Attached are answers to the questions on the draft criteria document concerning occupational exposure to polychlorinated biphenyls.

POLYCHLORINATED BIPHENYL EXTERNAL REVIEW QUESTIONS

Figure 7

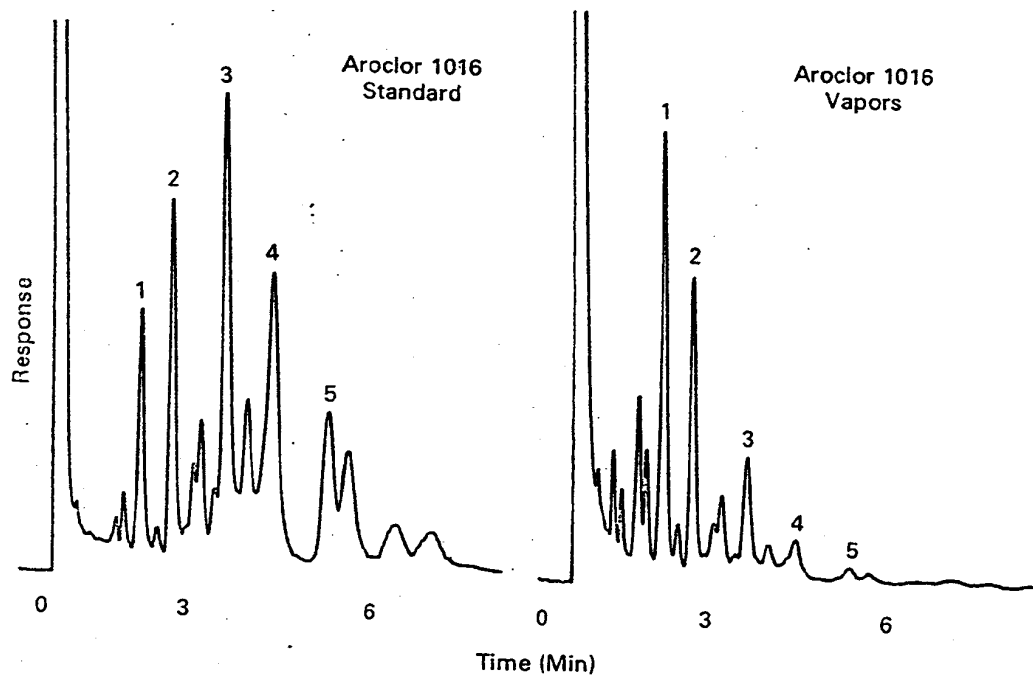
3. Vapor pressure differences alter the composition of vaporized PCBs relative to the liquid. (See attached figure showing chromatograms of liquid and vapors from Aroclor 1016).
